TVA-SQN-TS-03-06

**SEQUOYAH NUCLEAR PLANT (SQN) - UNIT 2 - TECHNICAL
SPECIFICATIONS (TS) CHANGE 03-06 - CHANGE INSPECTION SCOPE
FOR STEAM GENERATOR (SG) TUBES**

TENNESSEE VALLEY AUTHORITY SEQUOYAH NUCLEAR PLANT (SQN) UNIT 2

Figure 4.1

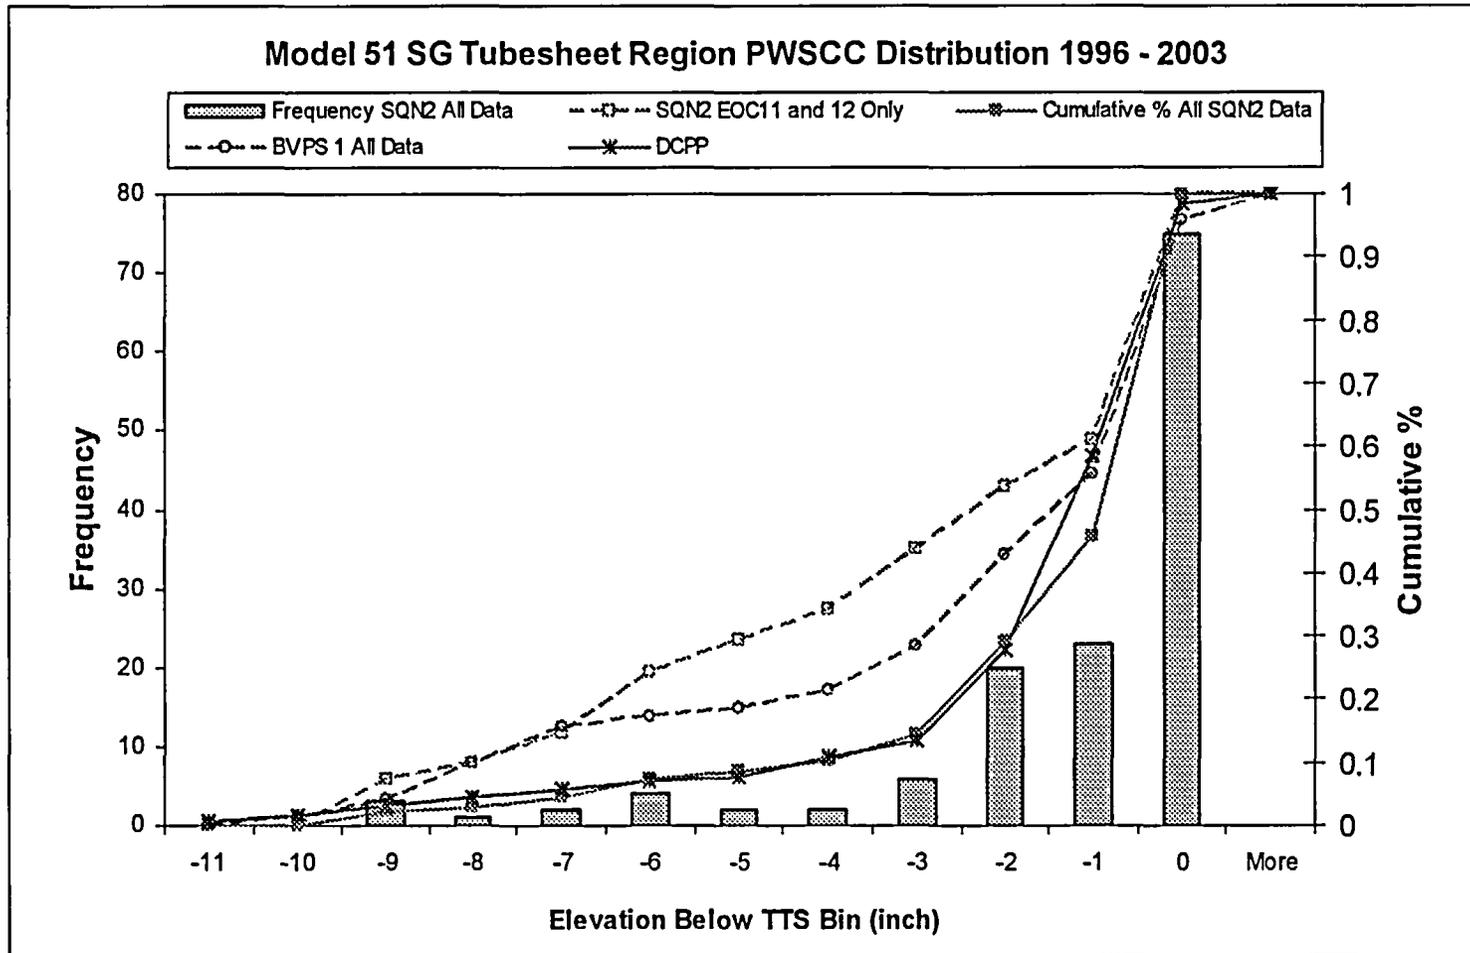
Figure 4.1 presents a cumulative distribution plot of elevations of all PWSCC indications reported at SQN2. Since elevation information is not available for the EOC-7 and earlier outages, the total number of indications reported from these outages were assigned to elevation bins based on the elevation distribution for the EOC-8 and later outages. This plot clearly shows that the PWSCC initiation potential is significantly greater for the top of tubesheet region than at deeper elevations. Recall that for the EOC-10 and all early outages, the +Pt inspection distance below TTS was 2 inches while for the EOC-11 and EOC-12 outages the +Pt inspection distances below TTS were 5.5 and 8 inches respectively. Figure 4.1 shows no increased initiation potential for indications at deeper elevations below TTS.

Figure 4.1 also presents cumulative distribution data of PWSCC as a function of elevation for the EOC-11 and EOC-12 outages only. For these outages, the inspection information for tube lengths never inspected can be used to formulate a judgment regarding indication potential at greater than 8 inches below TTS. At EOC-11, 26 total indications were reported with 14 located at greater than 2 inches below TTS, which was the bottom of the test extent for the EOC-10 outage. At EOC-12, 15 total indications were reported with 7 reported within 2 inches of TTS, zero reported between 2 and 5.5 inches below TTS (the bottom of test extent for the EOC-11 outage), and 8 reported at greater than 5.5 inches below TTS. The lack of new initiates in the 2

The elevation distributions for all data and the EOC-11/EOC-12 data are quite similar, further supporting the argument that PWSCC initiation potential below the transition region is far less than for the transition region. Note that for these plots, indication elevations between 0.00 and 0.99 inch below the top of tubesheet are found in the 0 inch bin. The SQN2 cumulative elevation distribution was compared against that of other plants with Model 51 SGs. The distributions for all plants are quite similar. Figure 4.1 also includes the Diablo Canyon Power Plant and Beaver Valley Power Station distributions which are similar to SQN2.

Figure 4.2

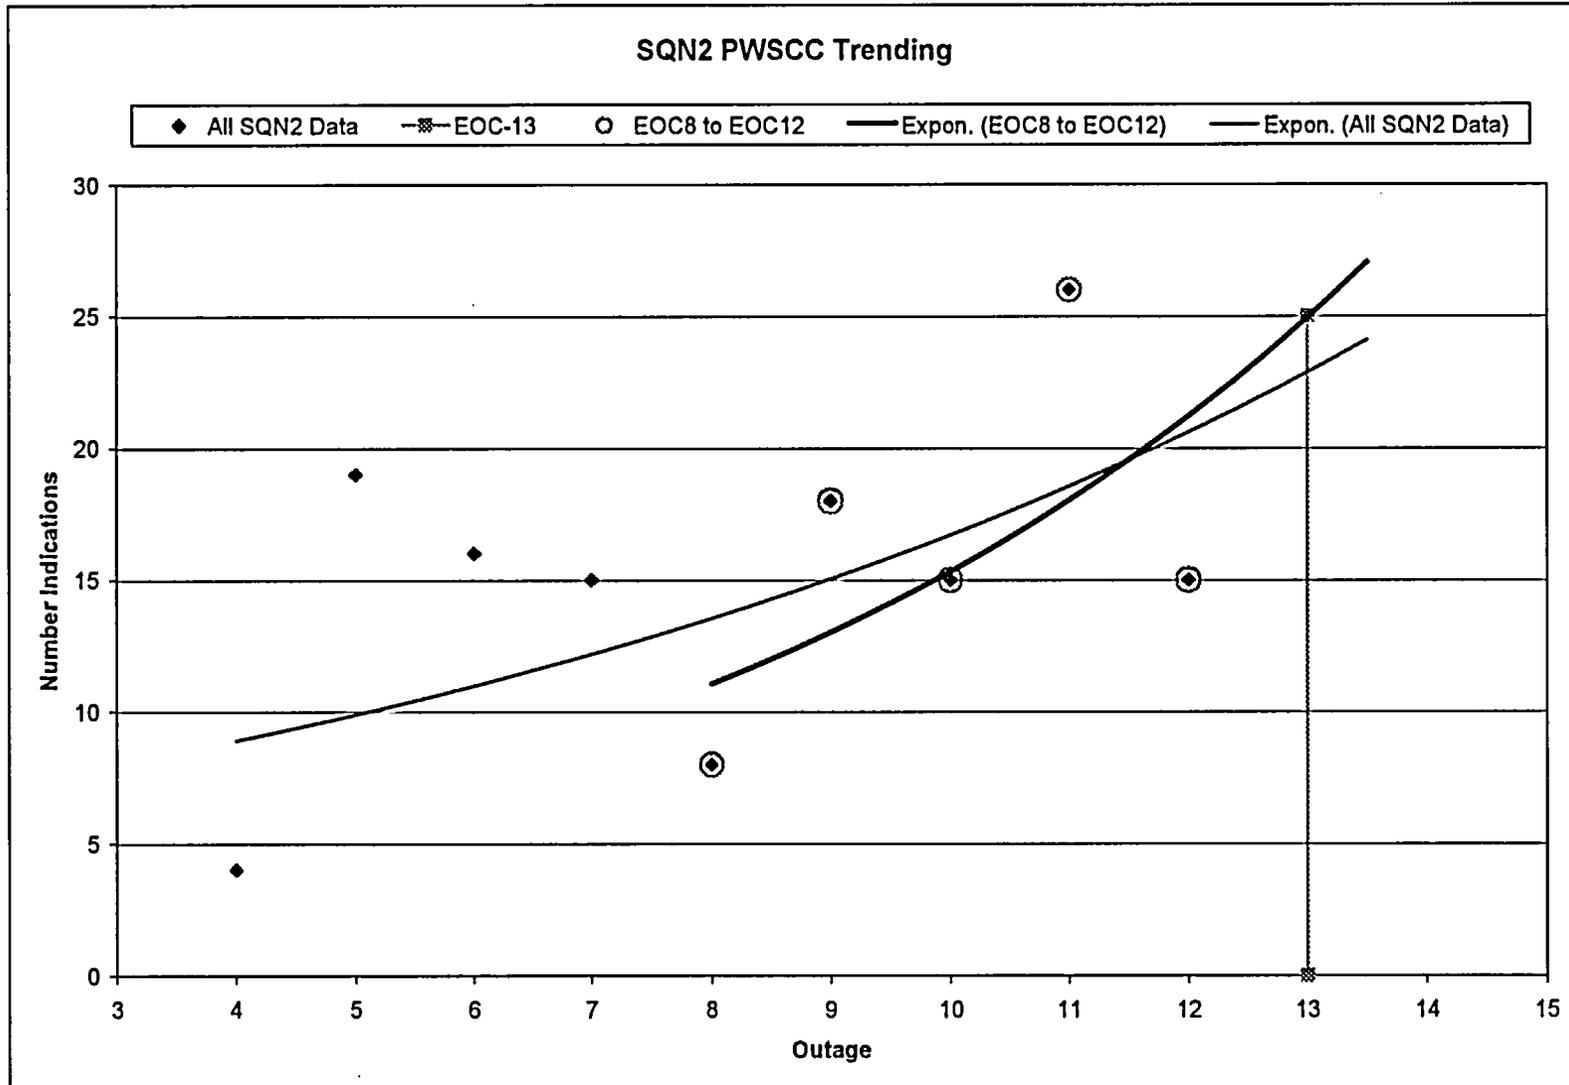
To date, 138 total indications have been reported, only 25, or 18%, of which were circumferentially oriented. Figure 4.2 illustrates the individual indication totals by outage. A regression analysis using all of the data suggests that approximately 23 indications are expected for the EOC-13 outage. Using only data from the last four outages, 25 indications are anticipated using a regression specific to that dataset. Therefore, the cumulative SQN2 total number of indications including the EOC-13 projection is a maximum of 163 (138 plus 25). An additional 41 indications (25% of combined historical indications plus EOC-13 new indications) might be observed if the inspection distance were increased from 8 to 12 inches below TTS. A very small number of these 41 postulated indications between 8 and 12 inches below TTS would be expected to have all of the following characteristics;

Figure 4.3

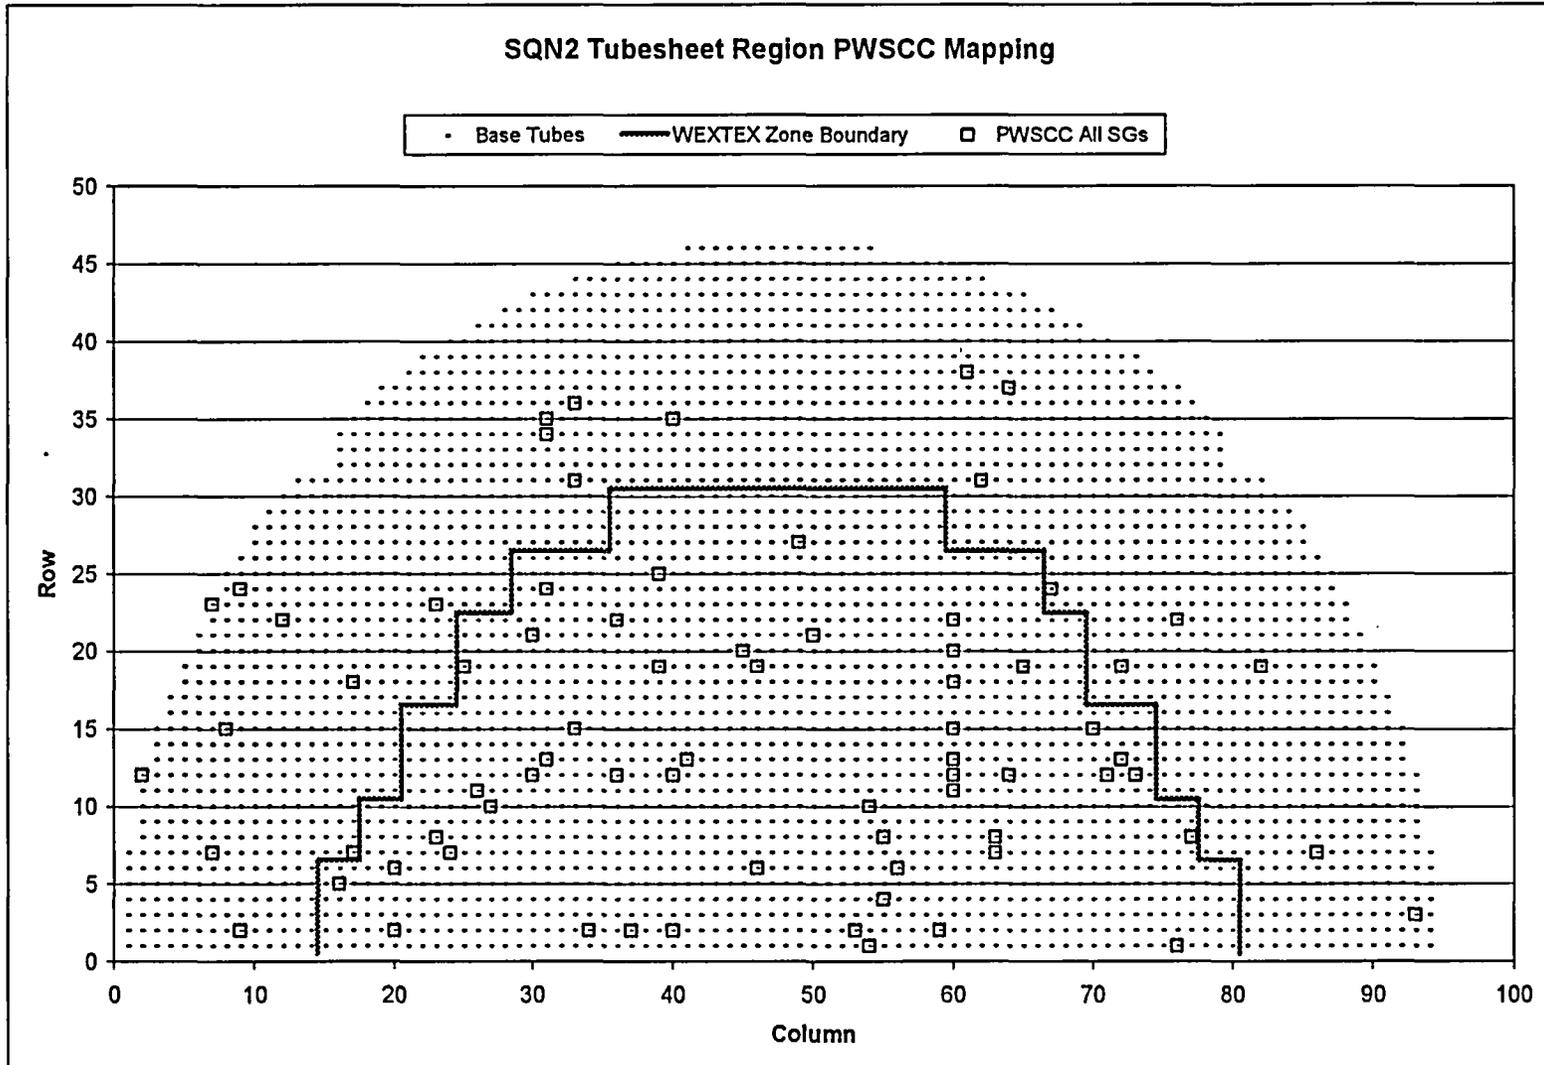
Figure 4.3 presents a tubesheet map plot of all Unit 2 PWSCC indications reported at EOC-8 and later. A total of 22 of the 82 indications in this population are reported to be in the outboard region, defined as Zone A, which is the zone with the lesser amount of tubesheet deflection during operating or faulted conditions.

Figure 4.4

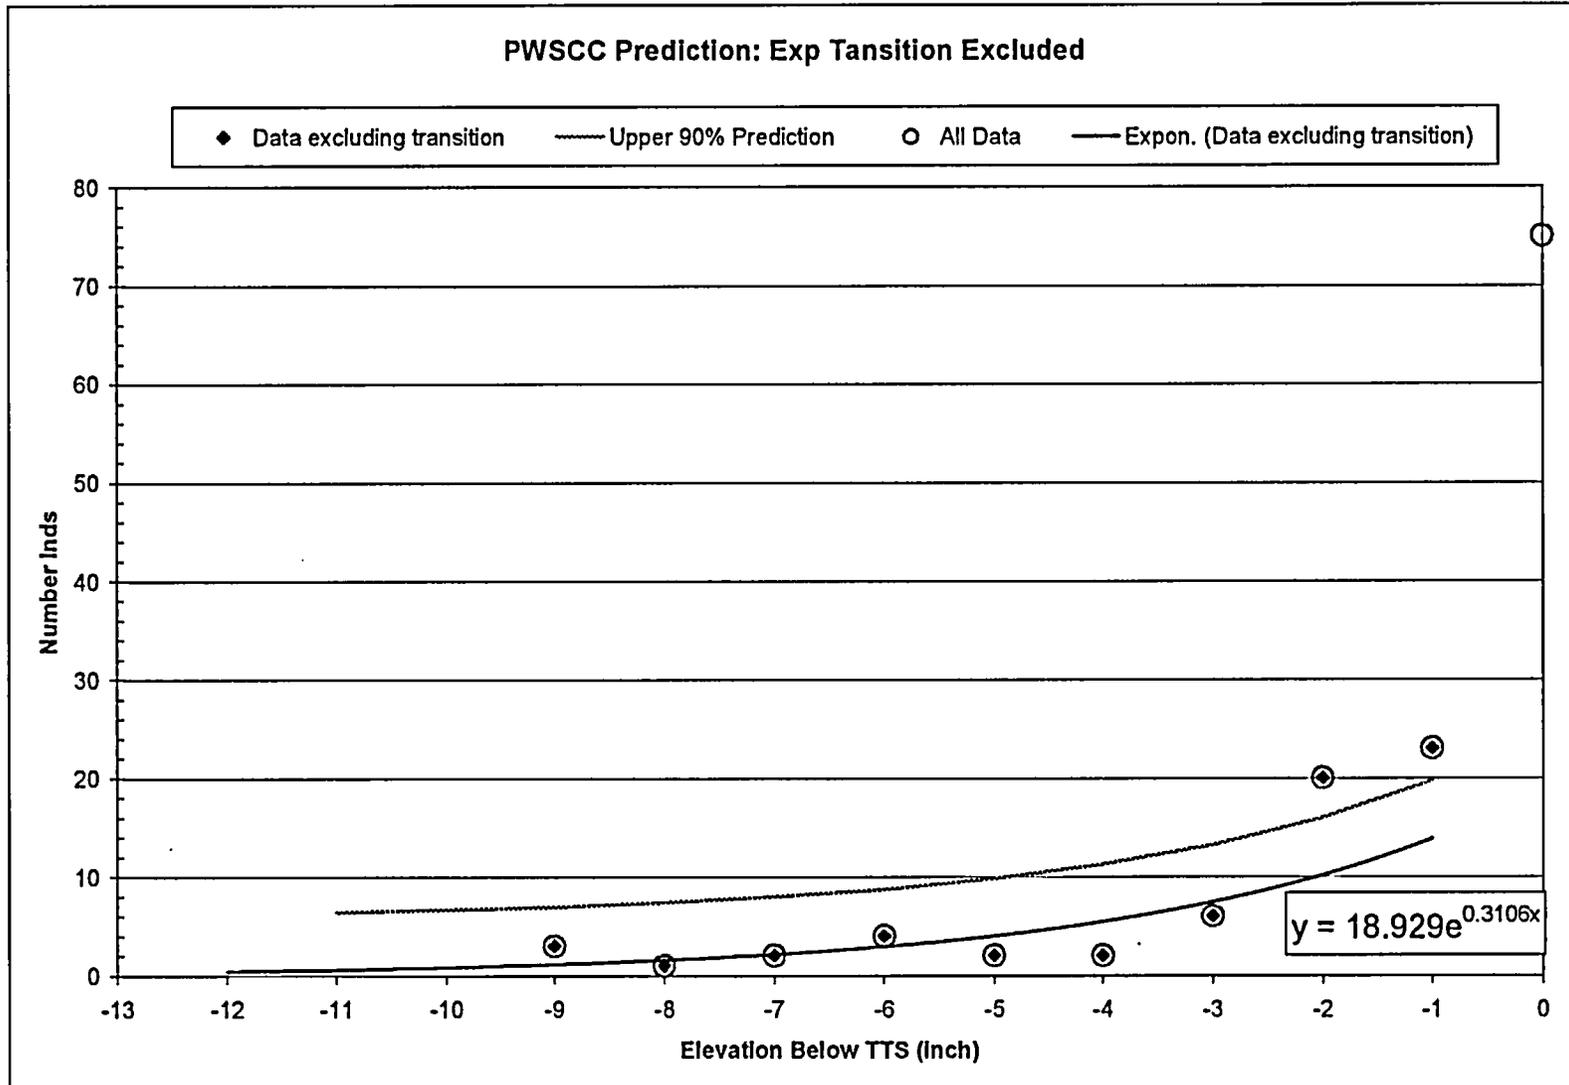
Figure 4-4 also includes an upper 90% probability prediction bound for this data. The 95% prediction correlation suggests approximately 27 indications would be expected at > 8 but < 12 inches below the TTS. For conservatism, the previously established value of 41 will be applied.
